PREPARED	NAME L. Pazmany	Mar. 7-73	PAZMANY AIRCRAFT CORPORATION — SAN DIEGO — CALIFORNIA —	MODEL NO.	PL-4A
CHECKED			ENGINEERING CHANGE NOTICE #1	REPORT NO.	
APPROVED				PAGE NO.	1

DWG 4-10-001 - WING ASSEMBLY - (OPTIONAL CHANGE)

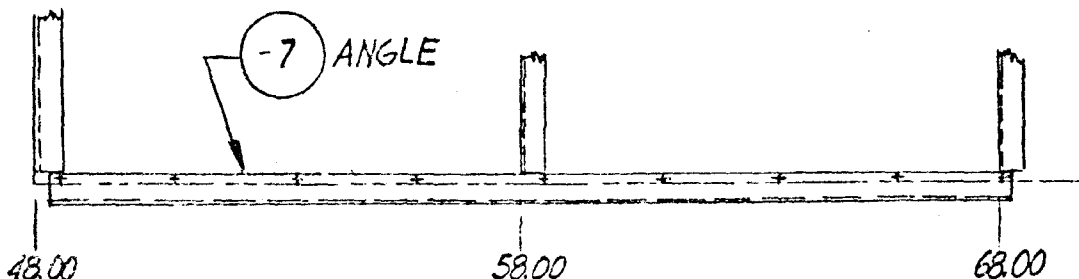
DURING FLIGHT TESTING IT WAS FOUND THAT THE LEFT WING DROPPED FIRST CONSISTENTLY. THIS COULD BE A RESULT OF A MISALIGNMENT OF THE WINGS. THIS TENDENCY WAS CORRECTED BY ADDING ANOTHER STALL STRIP IN EACH WING PANEL AS SHOWN ABOVE. THIS COULD BE A PARTICULAR SITUATION WITH THE PROTOTYPE ONLY, AND MAY NOT BE REQUIRED IN YOUR AIRPLANE. IF YOU FIND THE SAME SITUATION IN YOUR AIRPLANE, INSTALL STALL STRIPS AS SHOWN ABOVE BUT ONLY TAPPED TO BEGIN. RIVET STALL STRIPS IF IT HELPED.

DWG 4-50-003 - AILERON CONTROL INSTALL.

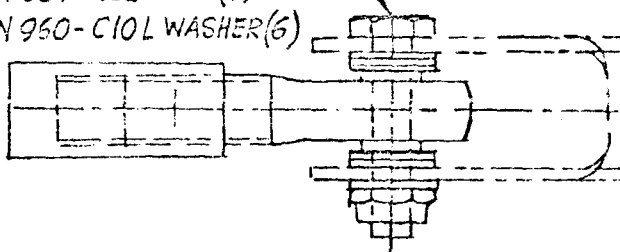
NAS 1103-12 BOLT (1) (MANDATORY CHANGE)
AN 364-1022 NUT (1) TO CORRECT ERROR
AN 950-C10L WASHER (6)

DWG. 4-10-004 - AILERON - (MANDATORY CHANGE)

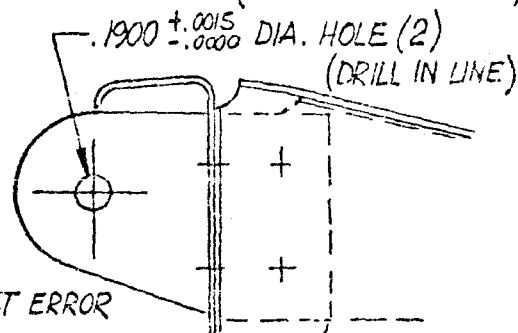
TO CORRECT ERROR

DWG. 4-30-002 - FIREWALL ASSEMBLY.

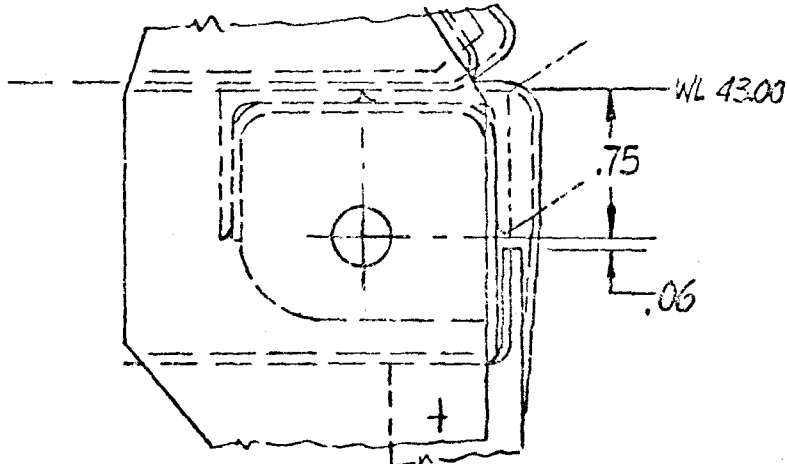
(MANDATORY CHANGE) - TO CORRECT ERROR DRAWING WAS OUT OF SCALE. LOCATION OF HOLE FOR ENGINE MOUNT BOLT WAS SHOW AT .67 BELOW WL 43.00. ALSO CORRECT LOCATION OF THIS HOLE IN DETAIL OF -31 GUSSET

DWG. 4-30-002 - FIREWALL ASSEMBLY

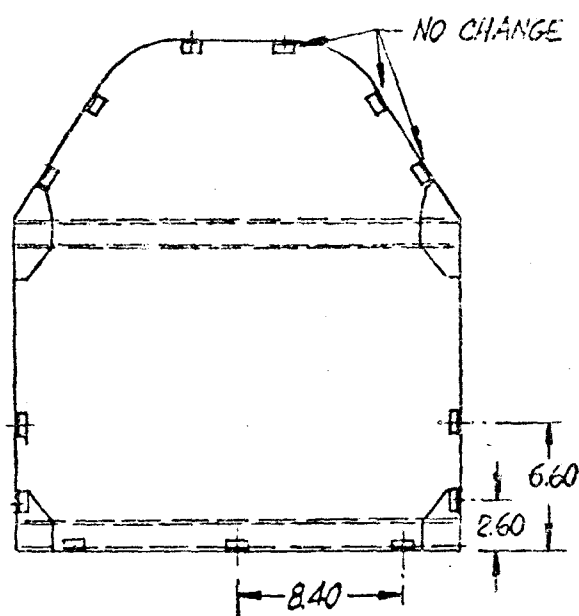
(MANDATORY CHANGE) - TO CORRECT ERROR.

THE LOCATION OF -19 ANGLES WAS CHANGED AT THE TIME OF INSTALLING THE COWL. THIS CHANGE WAS NOT INCORPORATED IN THE FIREWALL DWG. THE ANGLES -19 AND THE CAMLOC RECEPTACLES FOR THE UPPER COWL ARE NOT CHANGED. THE ANGLES -19 FOR THE BOTTOM COWL ARE RELOCATED AS SHOWN. USE NAS 697-A08K NUTPLATES (7 PLACES) INSTEAD OF CAMLOCKS FOR THE BOTTOM COWL.
